Re: Planning Reference 2023/1237/P, 20 Denning Road

The Hampstead Neighbourhood Forum objects to the proposed altering of the front boundary wall as contrary to the Hampstead Neighbourhood Plan.

Number 20 and 18 Denning Road

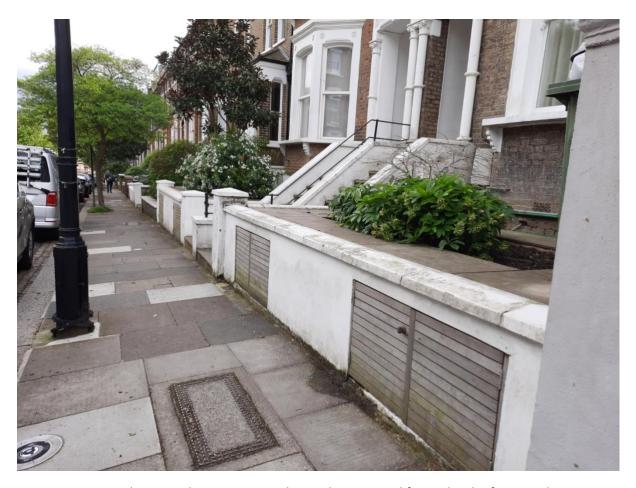
The Design & Access Statement states that similar bin store areas have been constructed in the front gardens at numbers 4 and 6 Denning Road (see photo) but in these properties the front wall is a retaining wall and the storage area built under the garden area. Number 2 is a unique house with bin access through a high wall. Throughout the rest of the street no bins are accessible directly from the pavement. The wall of number 20 currently mirrors that of number 18, forming a balanced pair (see photos).

Bin storage at numbers 4 and 6 Denning Road is unobtrusive and fits under the front garden.

The proposal is similar to 2019/0911/P, to which the Forum initially objected. The proposal was revised to remove the alterations to the boundary wall. We recommend the proposal for 20 Denning Road be similarly amended.
